SUBJECT: ISSUANCE OF AMENDMENT FOR THE WASHINGTON PUBLIC POWER SUPPLY SYSTEM  
NUCLEAR PROJECT NO. 2 (TAC NO. M88839)

Amendment No. 122  
License No. NPF-21

SAFETY EVALUATION BY THE OFFICE OF NUCLEAR REACTOR REGULATION  
RELATED TO AMENDMENT NO. 122 TO FACILITY OPERATING LICENSE NO. NPF-21  
WASHINGTON PUBLIC POWER SUPPLY SYSTEM  
NUCLEAR PROJECT NO. 2  
DOCKET NO. 50-397

FIGURE 3.4.6.1.c

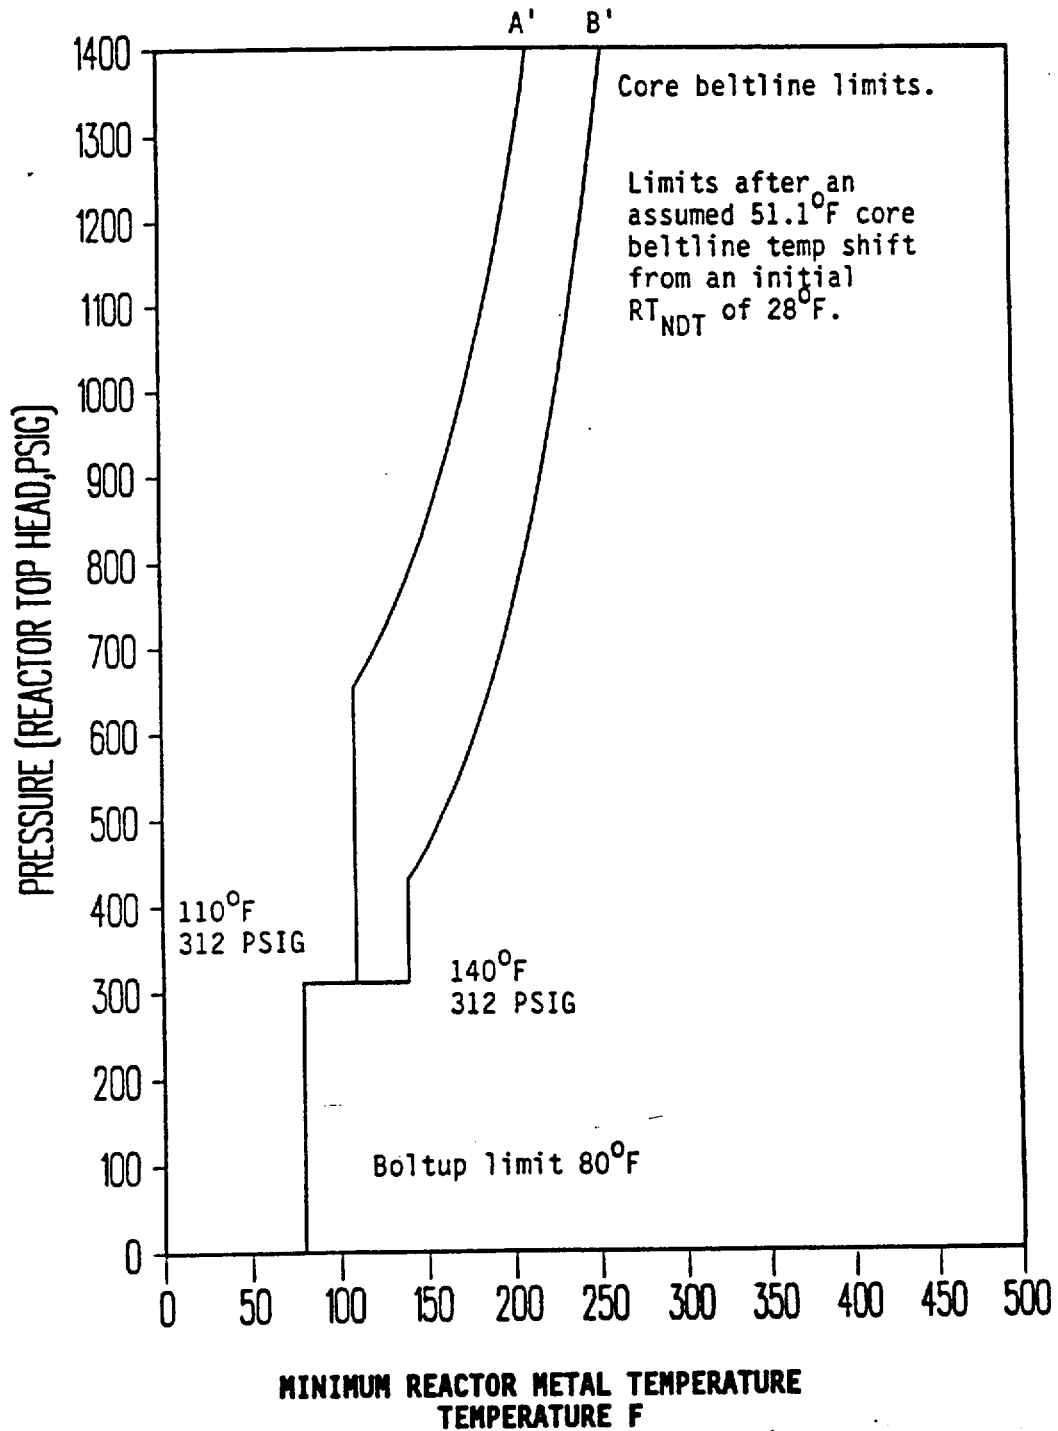
The problem in keeping the plant in Operational Condition 4 during testing is that TS 3.4.6.1 gives RCS pressure and temperature (P-T) limits for the tests. Current TS 32-EFPY P-T curves require reactor vessel metal temperature to be about  $236^{\circ}\text{F}$  for hydrostatic testing. This exceeds the  $\leq 200^{\circ}\text{F}$  average reactor coolant temperature TS limit for plant Operational Condition 4. Thus, WPPSS has proposed using an 8-EFPY P-T curve where metal temperature will have to be only  $180^{\circ}\text{F}$  for testing.

## 2.2 New 8-Effective Full Power Year Pressure-Temperature Curve

The proposed P-T limits were based on the limiting material (plate C1272-1) adjusted reference temperature. The plate contains 0.15% copper and 0.6% nickel. The initial  $RT_{ndt}$  is 28°F. The licensee calculated a reference temperature shift of 51.1°F at the 1/4T (T is the beltline vessel thickness plus cladding) location based on a fluence of  $1.7E17$  neutron/cm<sup>2</sup> for the limiting plate. We identified the same plate as the limiting material, and we verified that the licensee's calculated temperature shift of 51.1°F is acceptable. The adjusted reference temperature is 79.1°F (51.1°F plus the initial  $RT_{ndt}$  of 28°F). We substituted the ART of 79.1°F into equations in SRP 5.3.2, and verified that the proposed P-T limits for hydrotest and non-nuclear heating meet Appendix G of the ASME Code.

Appendix G of 10 CFR Part 50 also imposes pressure and temperature requirements based on the closure head flange reference temperature. Appendix G, paragraph IV.A.2, has special requirements when the primary system pressure exceeds 20 percent of the preservice hydrostatic test pressure. In this case, the temperature of the closure flange regions highly stressed by the bolt preload must exceed the reference temperature of the material in those regions by at least 120°F for normal operation and by 90°F for hydrostatic pressure tests and leak tests. Paragraph IV.A.3 requires the minimum permissible

temperature to be 60°F above the closure flange reference temperature when water level is within the normal range for power operation and pressure is less than 20 percent of the hydrotest pressure. We determined that the proposed P-T limits include this requirement, based on the licensee's reported 20°F flange nil-ductility transition reference temperature.

We find that the proposed Special Test Exception, TS 3.10.7, as modified to remove the phrase "and the requirements of LCO 3.4.9.2, 'Reactor Coolant System - Cold Shutdown,' may be suspended" is acceptable. We also find that the proposed hydrotest and non-nuclear heating P-T limits conform to 10 CFR Part 50, Appendix G requirements and Generic Letter 88-11. Accordingly,

the licensee may incorporate the limits into the plant TS. The limits are valid for less than or equal to 8 EFPY. The licensee may also delete Table B 3/4.4.6-1 *Reactor Vessel Toughness* from the TS bases.
